Filing Fee	\$	<u>150</u>
Permit Fee	\$	
Tech Fee	\$	
Excise Tax	\$	
PSFS	\$	
Guaranty Fund	\$	<u>50</u>
Add'l per Fee	\$	
Total Fees	\$	
Sub-Total Paid	\$	
Balance Due	\$	
Check	#	<u>11615</u>

RE: **Building Permit # B15002513**  
**7374 Guildford Road**  
**Clarksville, Maryland 21029**

Further review is contingent upon submission of a revised building plan showing the following:

**BAT SITE PLAN**  
7374 GUILFORD ROAD

**PERMIT PLAN**

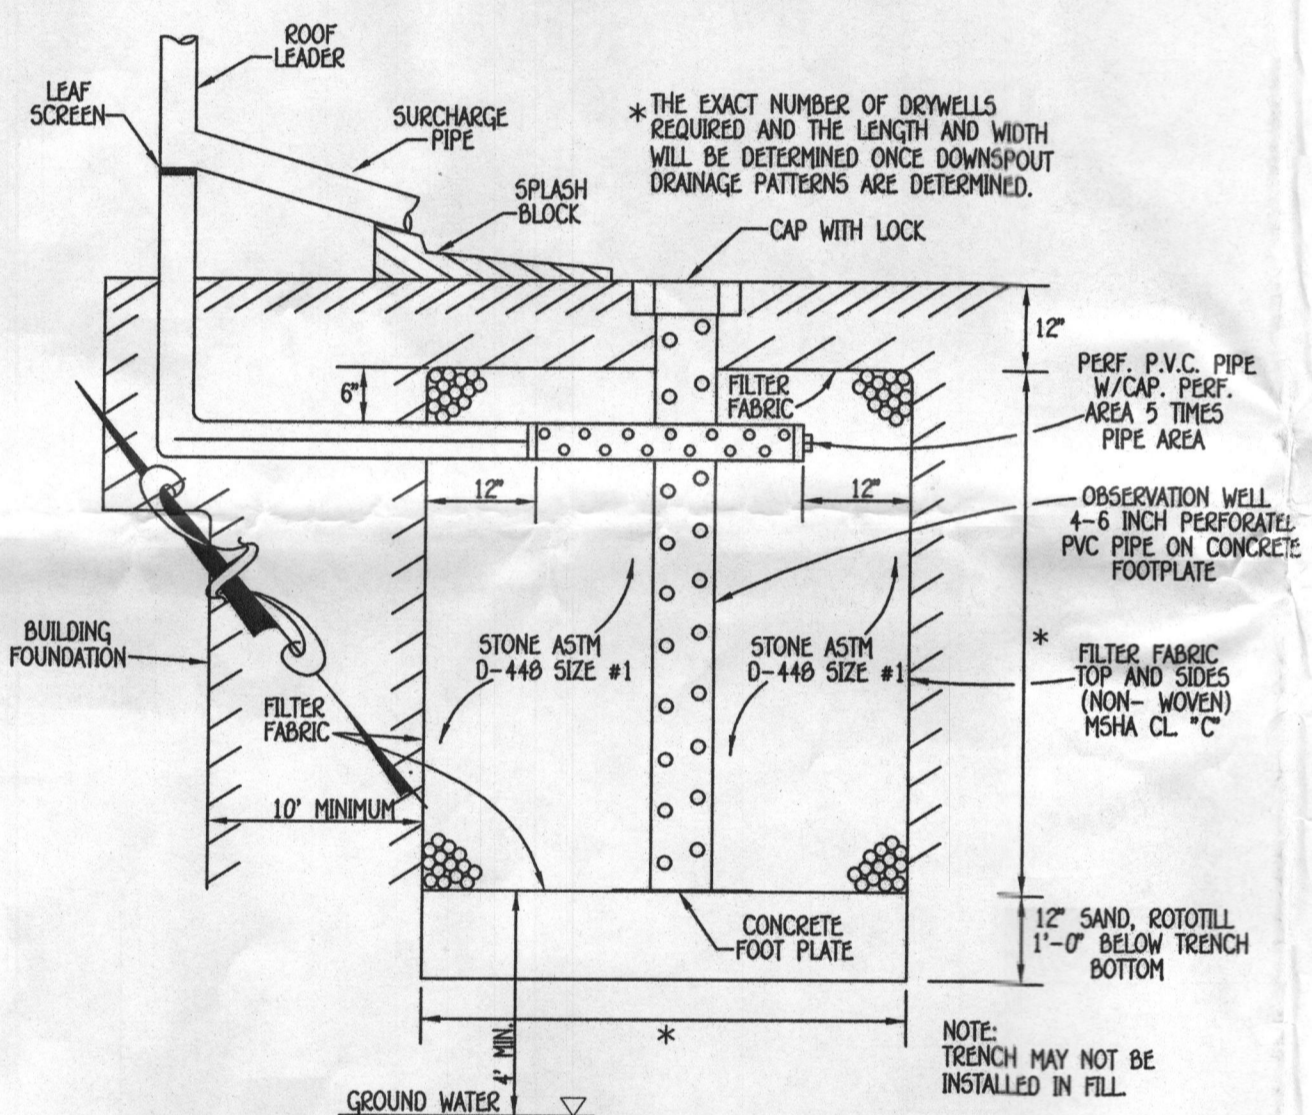
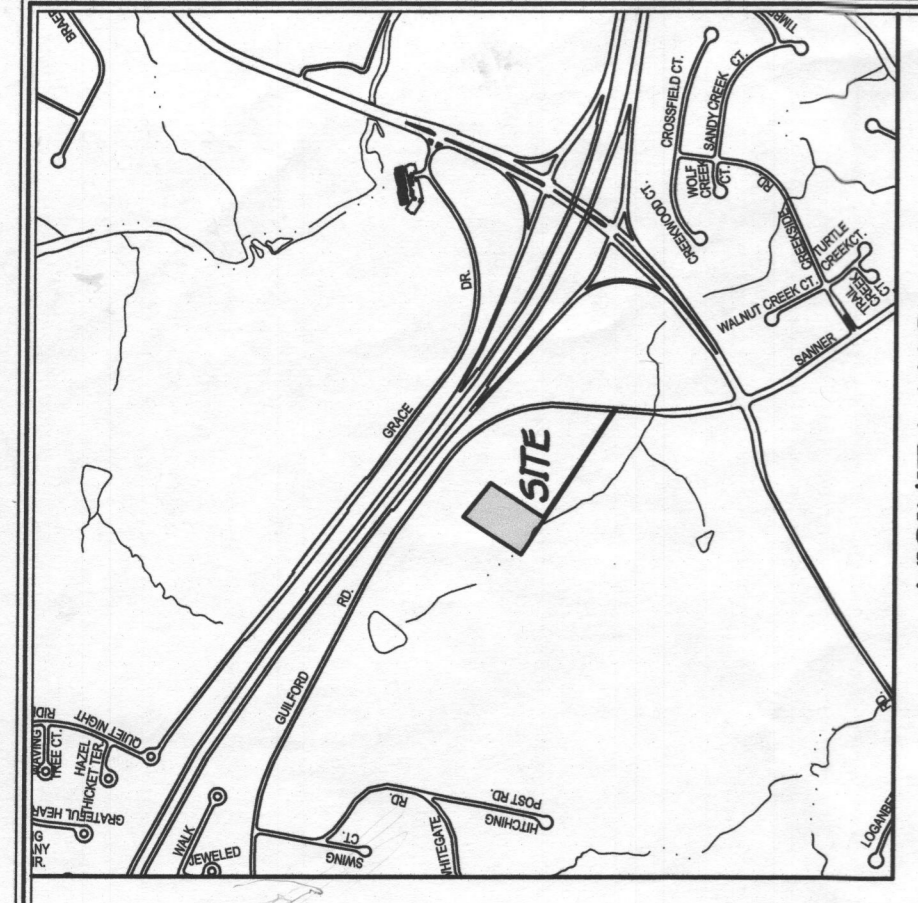
- Septic System and all of its components must be shown on plan.
- The well statement must be shown on building plan.
- Building plan must be to scale. (scale not shown)
- A well box (1500sq.ft.) or an initial drilled well with 2 alternate wells must be shown on plan.
